Appl. No. : 09/727,424
Filed : December 1, 2000

REMARKS

APPARATUS FOR OPTIMIZING CONTROL SYSTEM OF UNIT
DEVICE INTEGRATED IN MACHINE ASSEMBLY

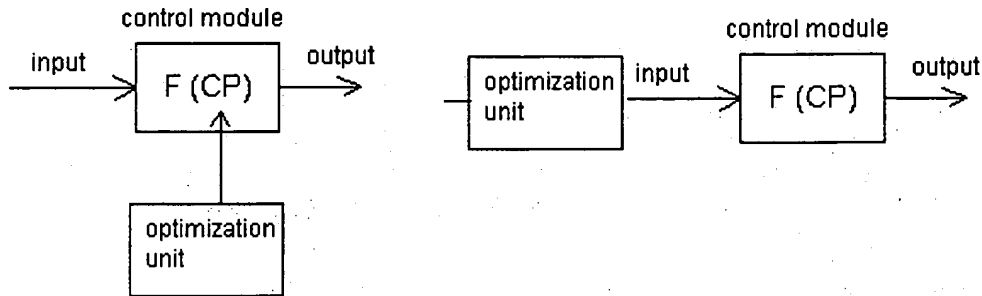
Claim 12 has been amended to further recite a basic control module in addition to the auxiliary control module arranged in parallel to or in a series with the basic control module (Figures 1b and 1c). In Lee, the Examiner thinks that the phase controller 18 is an auxiliary control module and the motor driving means 16 is a basic control module (because the auxiliary control module is subjected to optimization). However, as recited in Claim 11, the auxiliary control module is

regulated by control parameters, and the optimization process is applied to select the control parameters. In contrast, in Lee, a "control signal" (not control parameters) itself is outputted to the phase controller 18. Applying the optimization process to select control parameters (CP) is very different from applying the optimization process to output a control signal. See below.

Fig. 1e

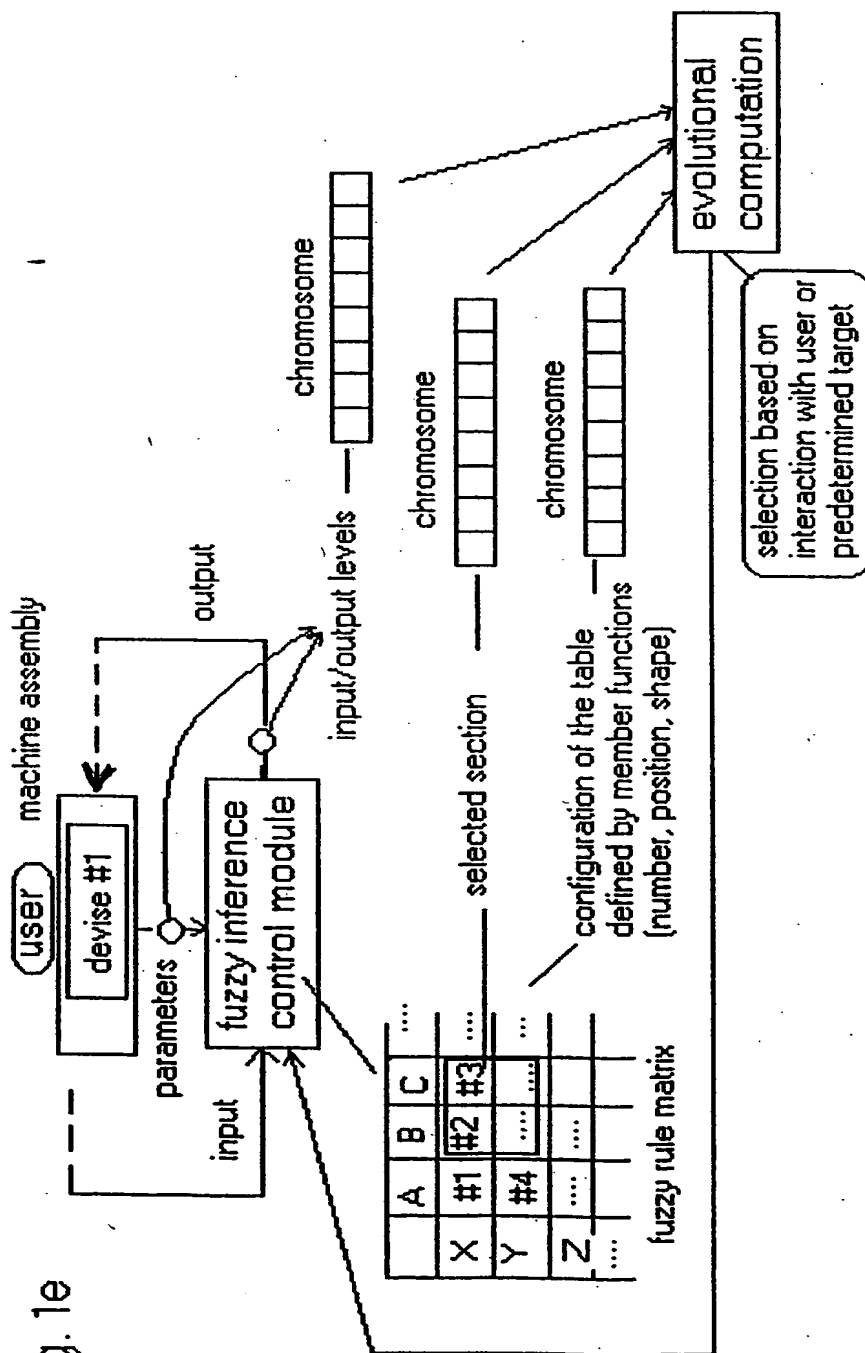
vii. The Examiner asserts that lines 24-26 of page 20 do not show any distinction between the autonomous evaluation and the interactive evaluation. The Examiner's assertion is not clear to Applicant. Figure 1e shows three ways to modify the matrix of fuzzy rules: (i) changing the membership functions, (ii) changing the fuzzy rules, and (iii) changing the input-output level (standardized coefficients) of the matrix (page 6). These are all parameters to regulate the matrix of fuzzy rules. The fuzzy rules can be expressed by numerals (e.g., Figure 7) and treated as parameters, as with the membership functions and the input-output level. In the above, (i) and (ii) may be suitably conducted by autonomous evaluation, whereas (iii) may be suitably conducted by interactive evaluation because it is preferable and easy for a user to evaluate the overall performance of the machine by judging the output of the control module (interactive evaluation). (i) and (ii) may require more complicated processing, and thus, it is more suitable to proceed autonomously, based on preselected target values. That is an embodiment explained in lines 24-26 of page 20. Applicant does not clearly understand the Examiner's assertion and believes that the sentence is not unclear.

FIG. 4

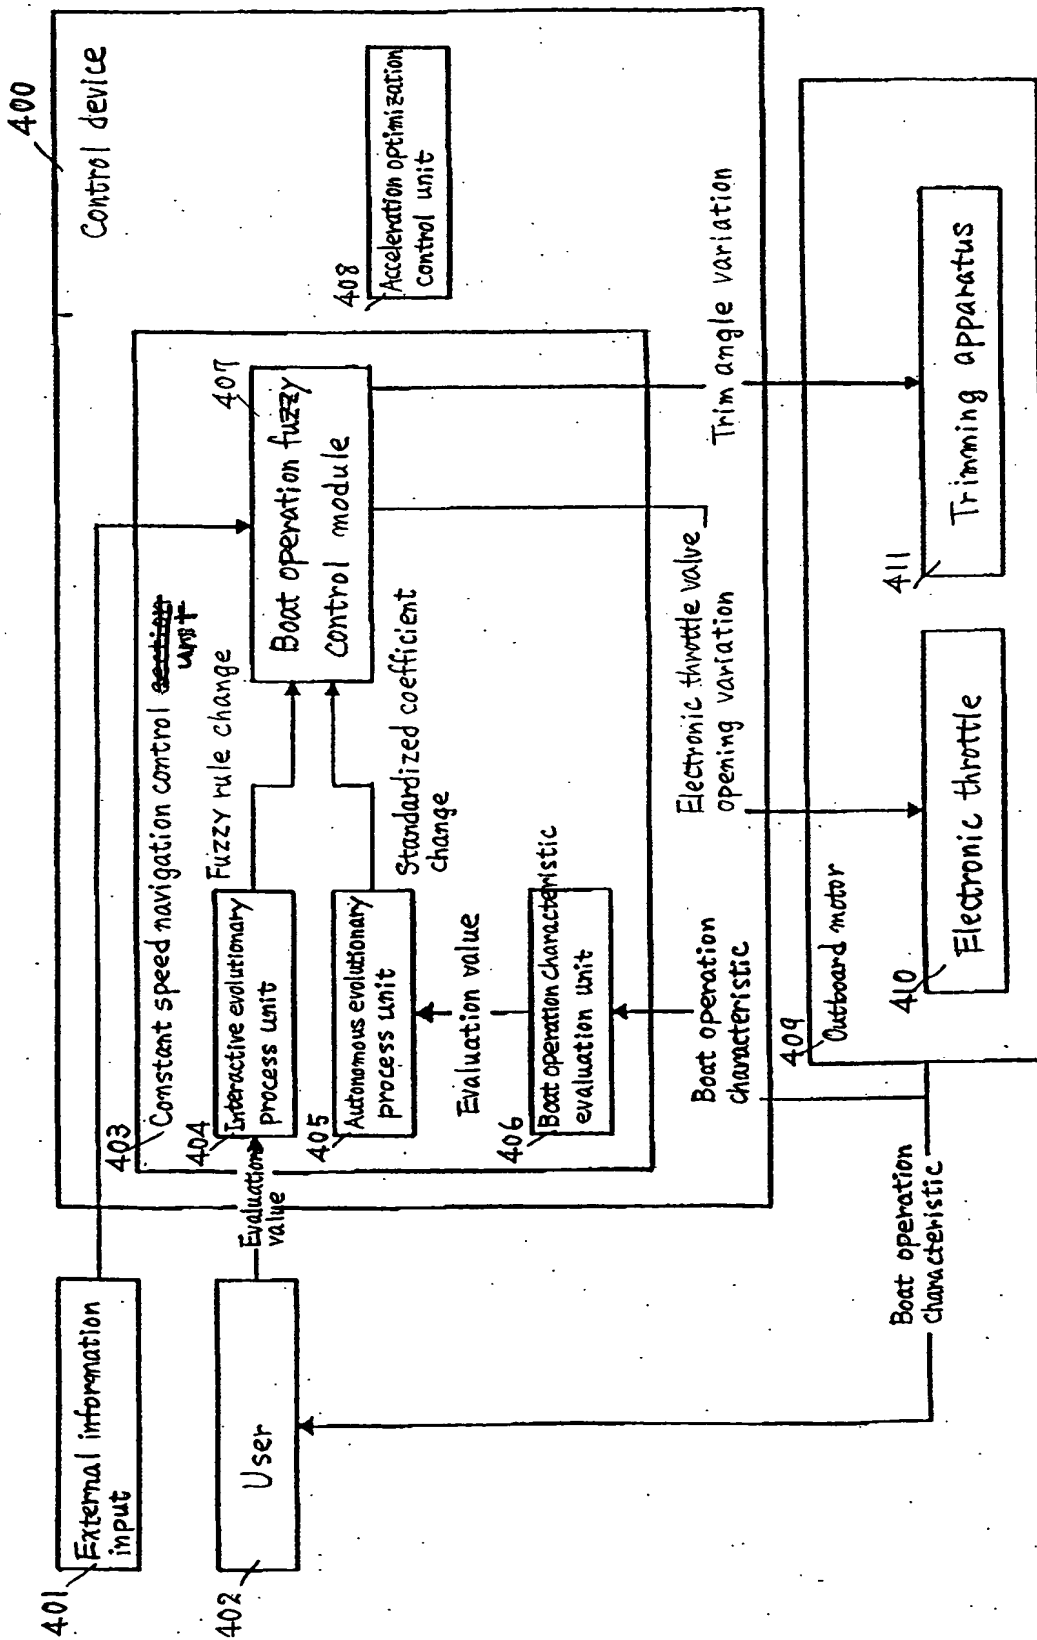
ii. The Examiner asserts that Figure 5 fails to show a throttle control element. However, as explained above, Figure 5 is a drawing for explaining the acceleration optimization control unit 408 which does not control the electronic throttle, whereas the constant speed navigation control unit 403 indicated in Figure 4 controls the electronic throttle. Thus, Figure 5 need not show a throttle control element.

However, Figure 5 is a drawing for explaining an acceleration optimization control unit 408 (previously 504) (page 10, lines 8-17), whereas Figure 4 is a drawing for explaining a constant speed navigation control unit 403 (page 9, line 28-page 10, line 7). As explained in the section "Control in Acceleration Optimization Control Section" on page 14, line 23 through page 17, line 19, the acceleration optimization control unit does not include the fuzzy control module (Figure 14). For the Examiner's reference, the description from page 10, line 20 through page 17, line 19 can be summarized as follows:

Figure 6 shows a boat operation fuzzy control module 407 (previously 60) which is included in the constant speed navigation control unit 403 in Figure 4 (page 10, line 27-page 11, line 14). Thus, contrary to the Examiner's assertion, Figure 5 should not show the fuzzy control module.

FIG. 5

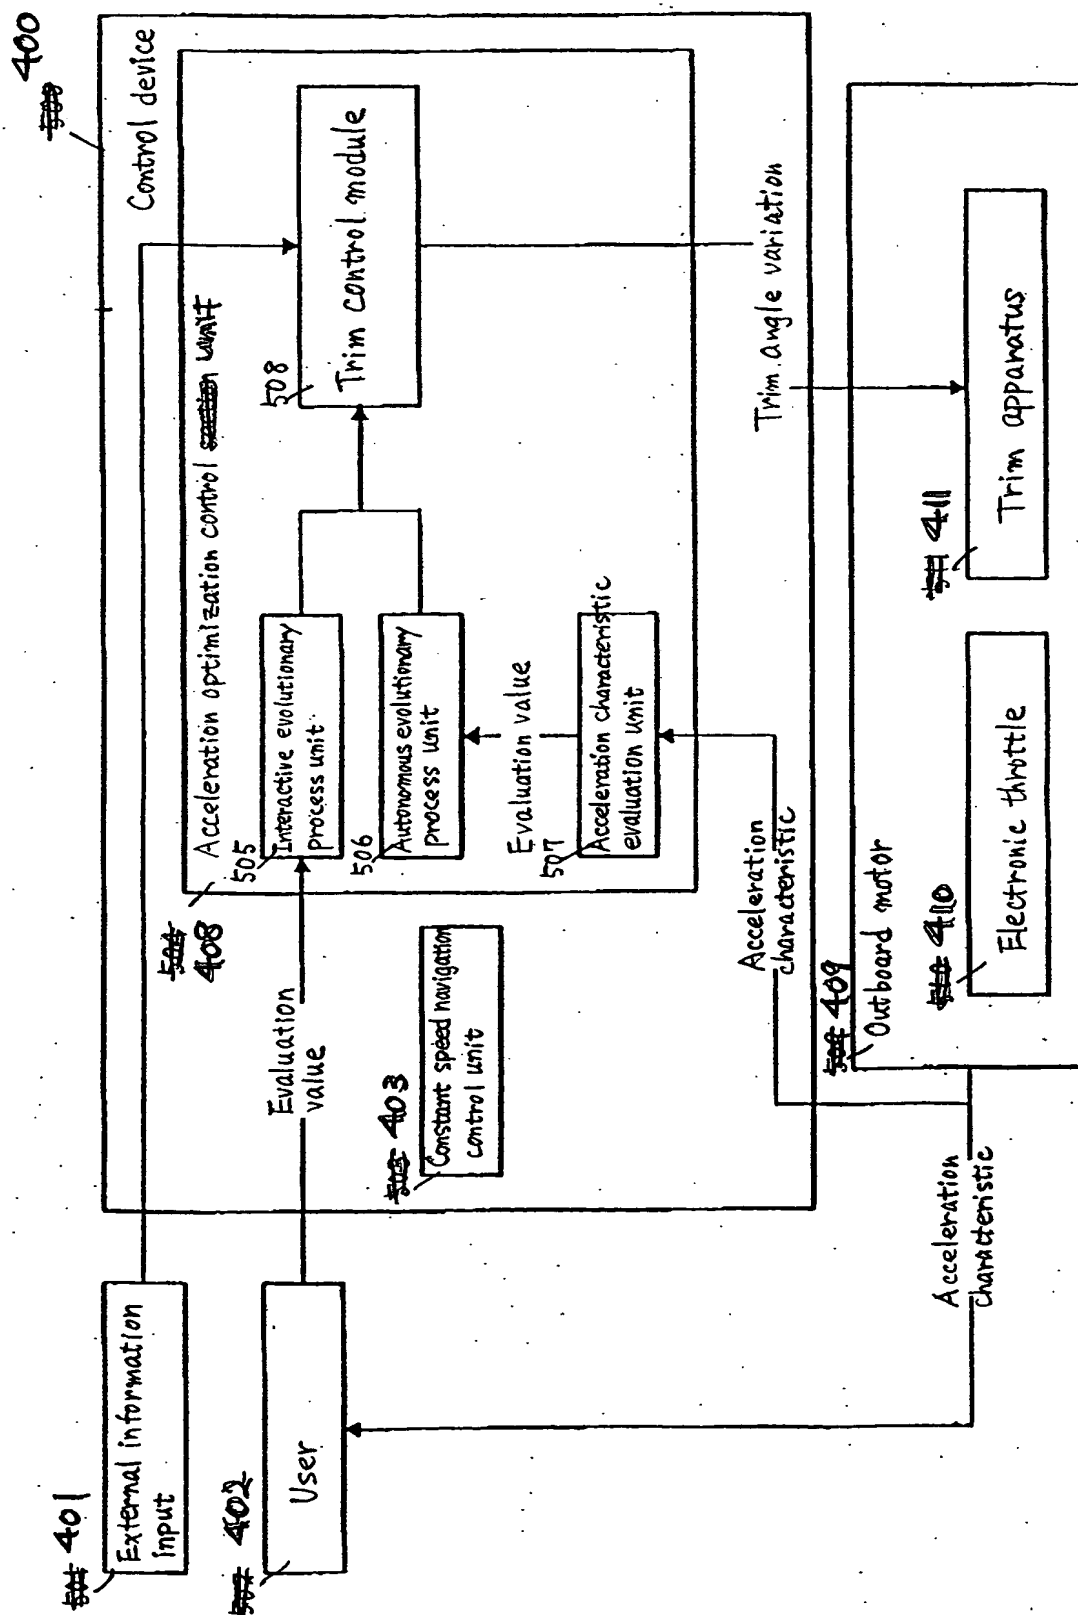
i. The Examiner asserts that Figures 5 and 6 fail to show the relationship between the fuzzy control module and the autonomous evolutionary process unit as described in the specification on page 11, lines 3-6.

FIG. 6

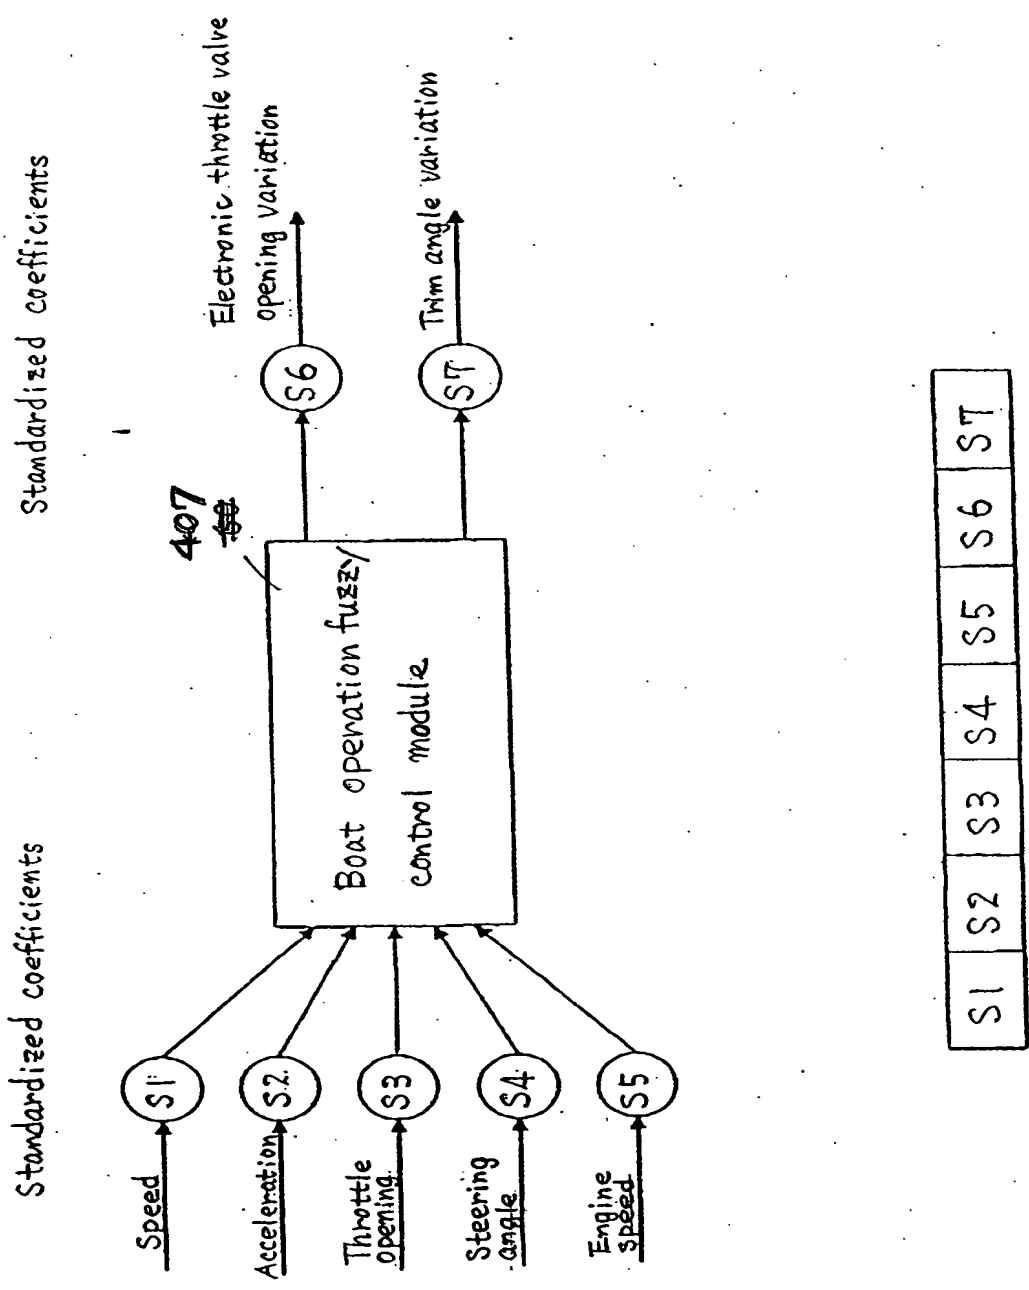
iii. The Examiner asserts that the figures fail to clearly show the relationship between the total table and the fuzzy table. However, as explained above, Figure 5 is not a drawing for explaining the fuzzy control. Figure 6 shows the boat operation fuzzy control module 407 wherein inputs from the interactive evolutionary process unit 404 and the autonomous evolutionary process unit 405 are omitted simply to show the input-output relationship. The functions of the boat operation fuzzy control module, the interactive evolutionary process unit, and the autonomous evolutionary process unit are explained in Figure 8, and the total table is explained in Figure 11. Thus, Figures 5 and 6 need not show the relationship between the total table and the fuzzy table.

FIG. 8

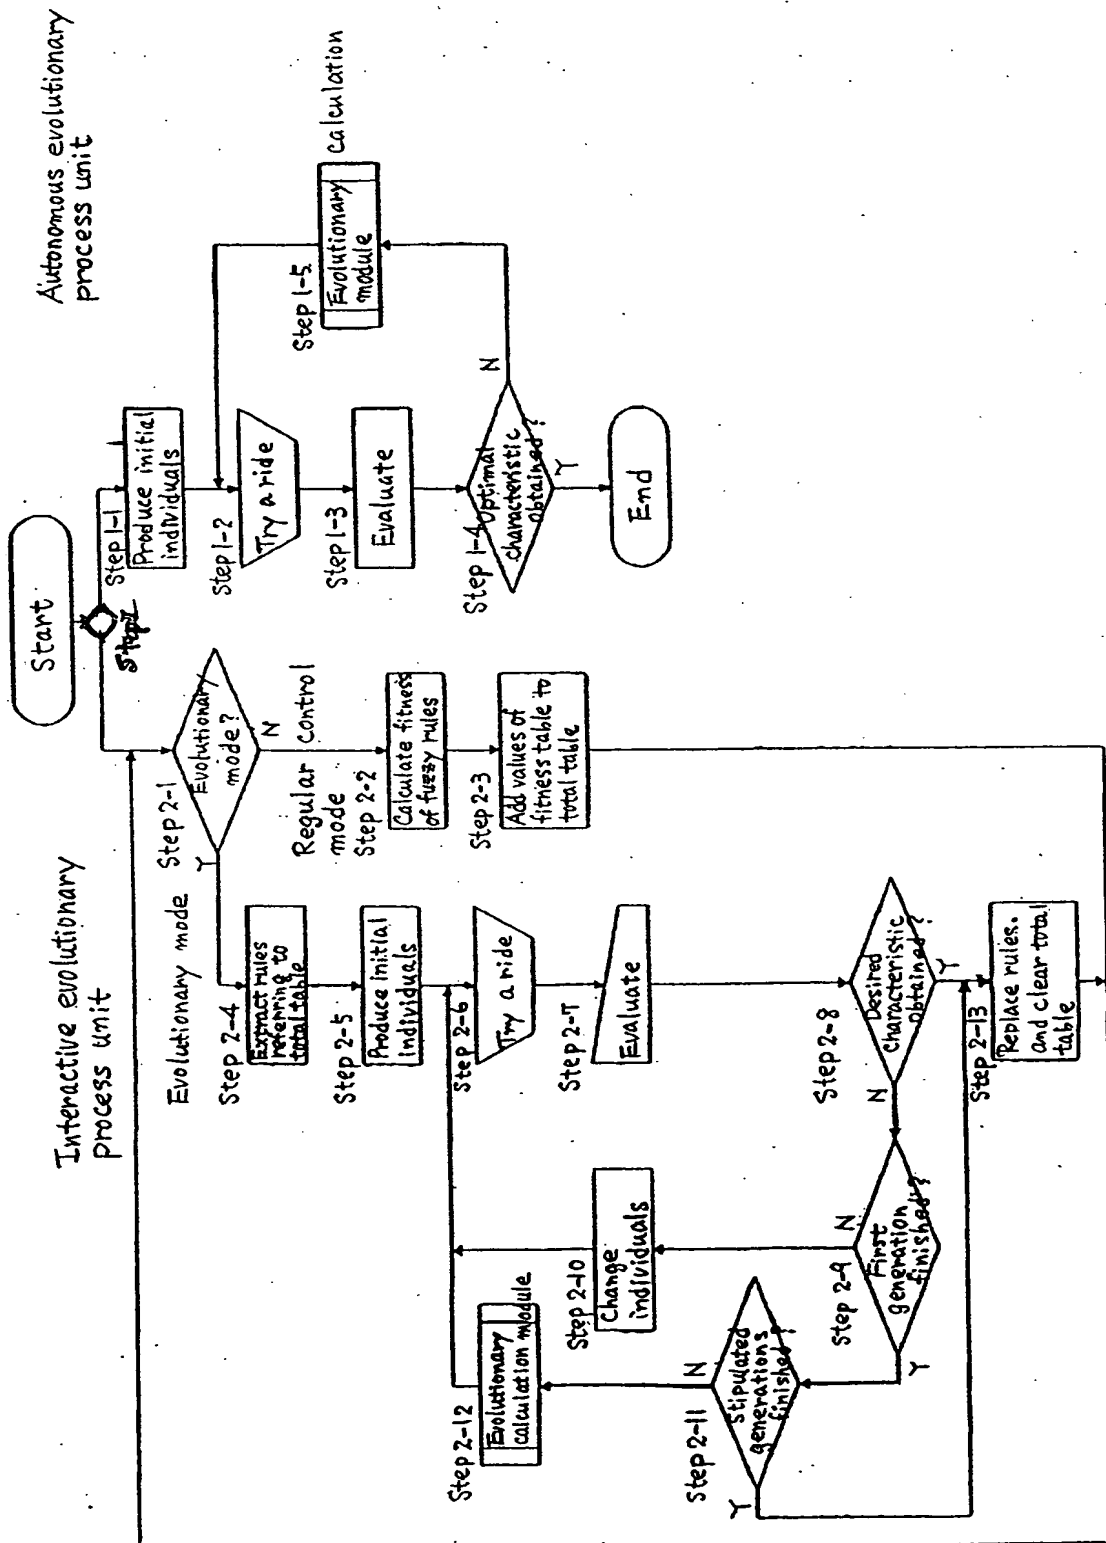
iv. The Examiner asserts that Figures 8 and 10 do not show a method for switching between autonomous evolution and interactive evolution. Figures 8 and 10 have been corrected in light of the Examiner's assertion.
